Jeff White
910 Windstar Blvd.
Franklin, IN 46131

February 15, 2019

City of Franklin Plan Commission
70 East Monroe Street
Franklin, IN 46131

As a resident of the Windstar Subdivision, I have several concerns regarding the proposed plat.

Zoning Map

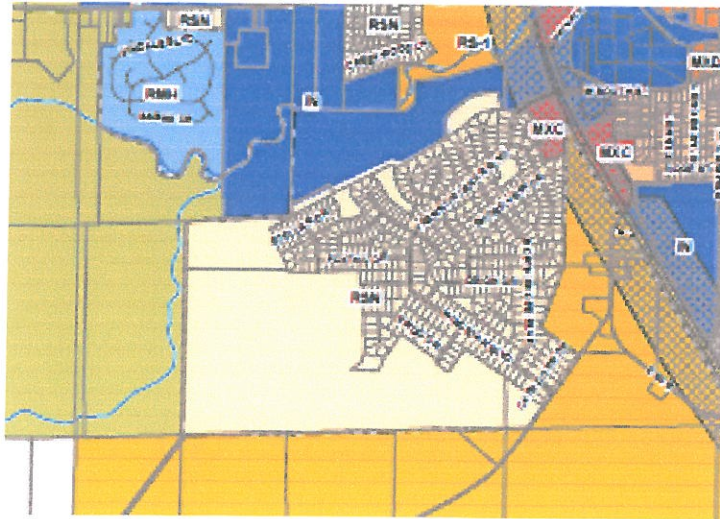
4. Zoning. The intent of zoning is to segregate uses thought to be incompatible. In practice, zoning is also used to prevent new development from interfering with existing uses and/or preserve the "character" of the community. Franklin's zoning map refers to Franklin Lakes, Windstar, and the adjacent field as "RSN". The Franklin zoning regulation states that RSN's minimum lot area is "equal to the smallest lot established by the same approved preliminary plat on the effective date of this ordinance". This also includes setback and space between houses. Since there is no preliminary plat yet approved, I argue that based on the definition of zoning, the map, and regulation, that the intent of the area labelled "RSN" should match the adjacent housing. This plat is simply a continuation of an existing subdivision as it uses minor streets to access.

I heard that the city could do nothing if the plat meets the requirements. The Plan Commission sets the requirements based on the zoning rules assigned "RSN" and standard zoning definitions. This is your opportunity to define the area based on your own designation, not the developer.

If you do not establish the requirement of equal to adjacent housing, the entire purpose of HOA and standards for community become irrelevant.

I ask that the "new" subdivision, although just an extension of an existing as long as there is no new entrance, have the same requirements as the existing subdivision in lot size, home size, and quality. Also, that another entrance be added that does not include Windstar Blvd/Franklin Lakes Blvd.
